**CITY OF MUSKEGON
HISTORIC DISTRICT COMMISSION
REGULAR MEETING**

DATE OF MEETING: Tuesday, April 6, 2021
TIME OF MEETING: 4:00 p.m.
PLACE OF MEETING: <https://www.facebook.com/CityofMuskegon>

AGENDA

UPPER FLOOR
SCALE 1/4" = 1'-0"

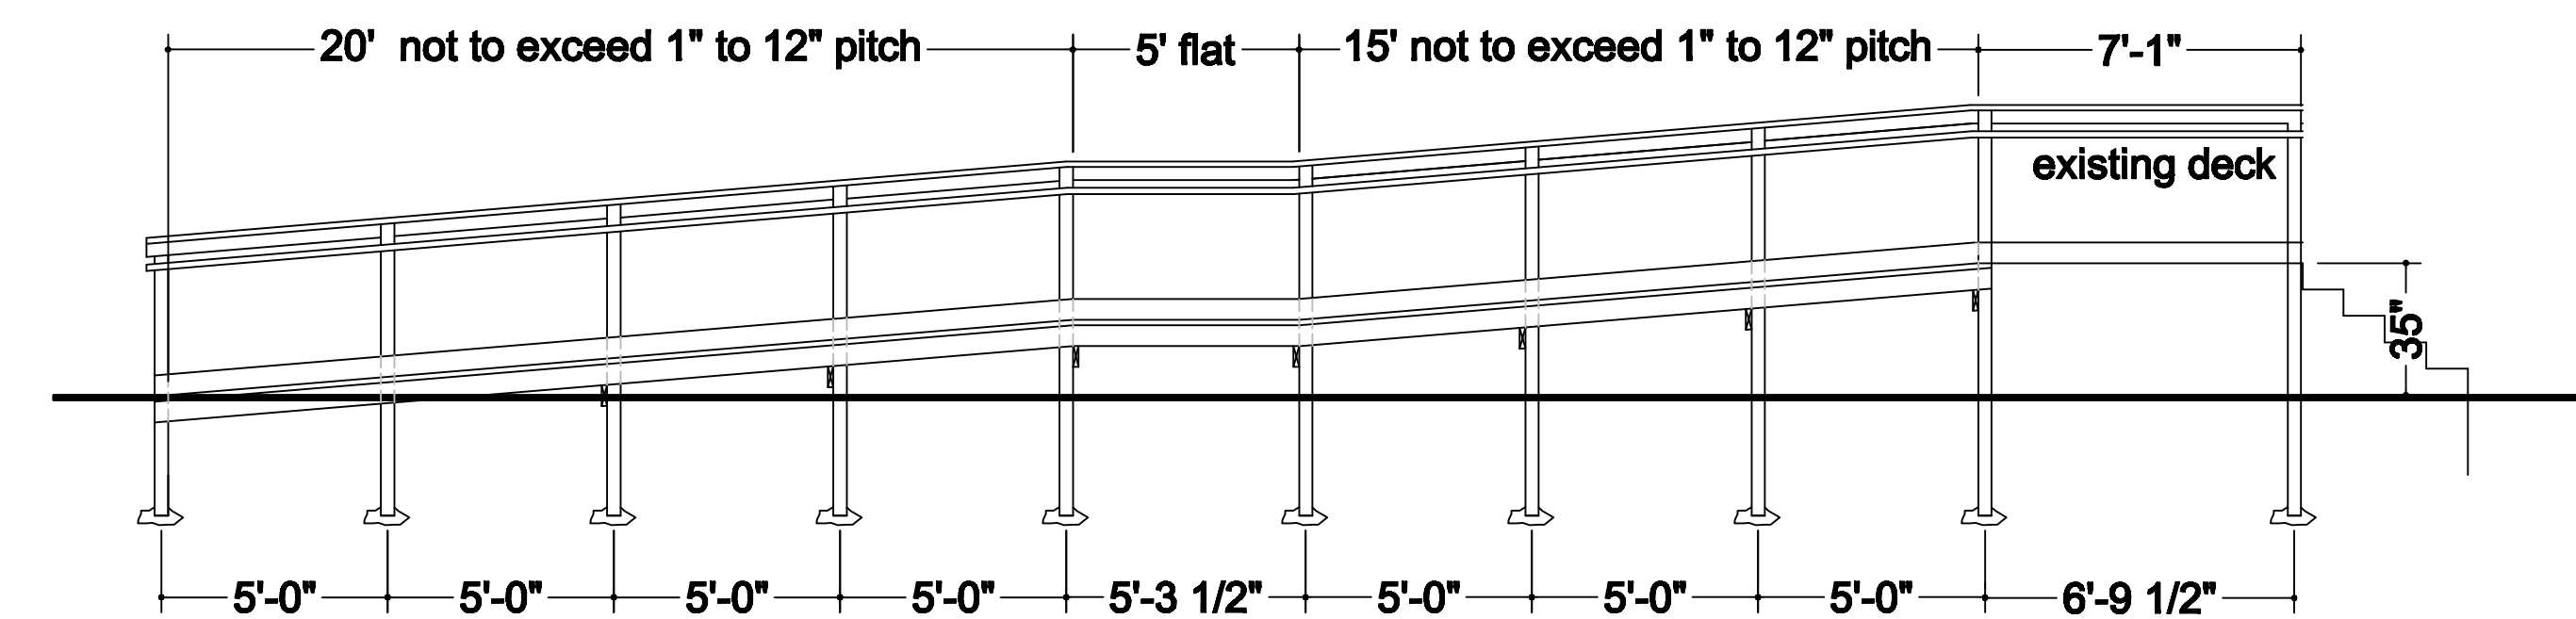
Case 2021-07 (Walk-on) – 1129 Peck Street (Accessible Ramp). Applicant: Step Up (Dick Kamps). District: McLaughlin. Current Function: Residential. J. Pesch presented the walk-on case. The applicant is seeking approval to install a new accessible ramp on the north side of the house. J. Pesch shared plan and elevation drawings for the proposed ramp, and photos of the north side of the house looking east toward Peck Street from the alley and west toward the alley from Peck Street.

D. Kamps noted that the ramp would lead from the alley, up toward Peck Street, to an existing side porch and stated that the ramp would be hardly visible from the street. S. Radtke asked if the existing door was of an ADA-compliant size. D. Kamps stated that the door was ADA-compliant at 36"-wide. S. Radtke asked what type of skirting was proposed for below the ramp. After further review of the drawings and photos, the board agreed that the side of the ramp that would typically require skirting was barely visible from the street. A. Riegler stated that if the ramp was on a primary elevation, the board would be more concerned with the ramp matching the house or having certain details. She noted that she was less concerned about these points due to the fact that the ramp would not alter the house, could easily be removed, and was largely hidden from view. D. Gregersen added

that adding more details to the ramp would only draw more attention to it. S. Radtke pointed out that the drawing showed a plain handrail on the ramp with it open underneath.

A motion that the HDC approve the request to construct a new accessible ramp along the north side of the existing house at 1129 Peck Street as shown in the drawings reviewed at the March 2, 2021 HDC meeting (Attachment A, below) as long as the work meets all zoning requirements and the necessary permits are obtained, was made by A. Riegler, supported by T. Emory and unanimously approved, with S. Radtke, T. Emory, A. Riegler, and D. Gregersen voting aye.
